**STAFF REPORT**  
December 6, 2016**AGENDA ITEM (File No. 16021)**

Consideration of a Site Plan and Architectural Review application for the construction of a 43,000 square foot corporate headquarters and light fabrication facility for Rogue Valley Microdevices. Rogue Valley Microdevices proposes to operate in the Thoroughfare Commercial (C-5) zoning district. The project site is located at 4901 Biddle Rd., and is defined on the Jackson County Assessor's map as 37S 2W 01C, Tax Lot 802.

**Applicant:** Rogue Valley Microdevices, Inc.; **Agent:** Jay Harland, CSA Planning.

AREA PLAN

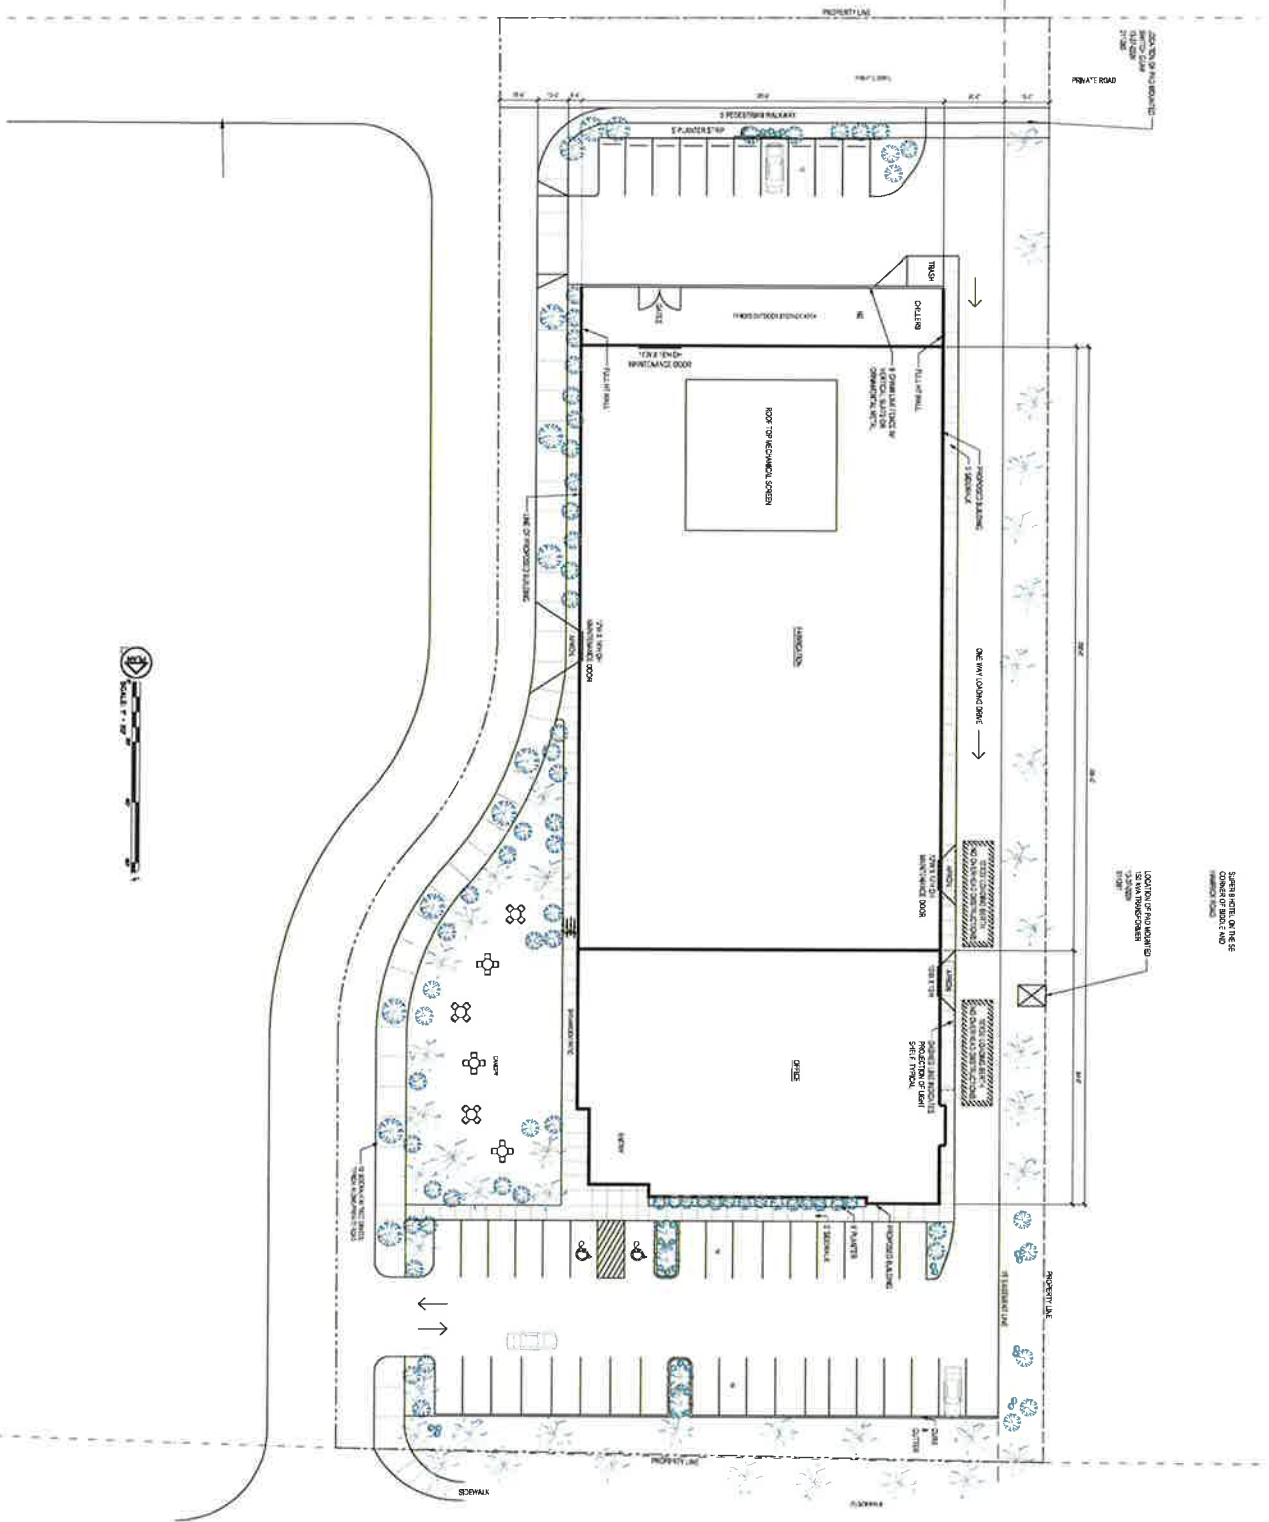
1. **Legal Lot Status.** At the time of this review, the 2.24 acre project site has been tentatively approved but not legally created. Since the Southern Oregon Specialty Veterinary Center occupies the parent parcel (Tentative Lot 1), construction activities may not commence until the final plat is recorded.

2. **Parking Adjustment.** Per Table 17.64.02B, the required amount of parking for a manufacturing facility is determined based on either the number of employees per shift or the square footage of gross floor area, whichever is greater. In this case, 86 parking spaces are required. The Applicant’s parking plan proposes 46 spaces. To meet the off-street parking interior landscape requirements (See Issue 3a), the applicant may lose one (1) space in the secondary parking lot south of the building resulting in 45 spaces. Provision of 45-46 spaces does not meet the minimum/maximum parking requirement.

3. **Off-Street Parking Landscape Requirements.** Proposed off-street parking lot landscaping improvements are not consistent with the requirements for interior islands and tree planting per CPMC 17.75.039(G)(2):

*Comment: Based on staff’s review, the interior landscape requirements can be met with minor modifications to the parking lot configuration (i.e. adding and modifying islands). The landscape islands within the north parking lot can be consolidated into two (2) 8-ft islands without losing any parking spaces. However, the addition of an interior island in the south parking lot appears to result in the loss of one (1) space. As demonstrated in the Applicant’s parking demand analysis (Attachment “D”), a total of 45 parking spaces would remain within the acceptable range of parking generated by the use.*

- b. **Trees.** CPMC 17.75.039(G)(2)(a-c) provides the tree planting requirements for off-street parking lot interior landscape areas (i.e. terminals and islands). The number of trees required is a function of the parking lot visibility from the public realm. Highly visible parking lots require more trees than those that are located away from public rights-of-way (i.e. behind buildings).

The north parking lot is between the primary building façade and Biddle Road and requires 1 tree for every four (4) spaces. There are 35 spaces requiring eight (8) trees; however, only two (2) are shown on the landscape plan (Attachment “B-5”). The south parking lot is behind the building and requires one (1) tree for every eight (8) spaces resulting in one (1) tree for the 10-11 space parking row. No trees are shown on the landscape plan at this location. Table 1 shows the tree planting requirements for each parking area.

*Staff recommends a revised Site Plan be submitted at the time of building permit application demonstrating compliance with the interior landscape requirements per CPMC 17.75.039(G)(2).*

*Comment: Staff recommends that a revised Landscape Plan be submitted at the time of building permit application demonstrating compliance with the interior landscape requirements for trees per CPMC 17.75.039(G)(2)(a) and (c).*

2. At the time of building permit application, the applicant shall submit a revised site plan and landscape plan demonstrating compliance with the off-street parking lot landscape requirements in CPMC 17.75.039(G)(2). Modifications that alter the site layout may be subject to CPMC 17.09, Modifications to Approved Plans.
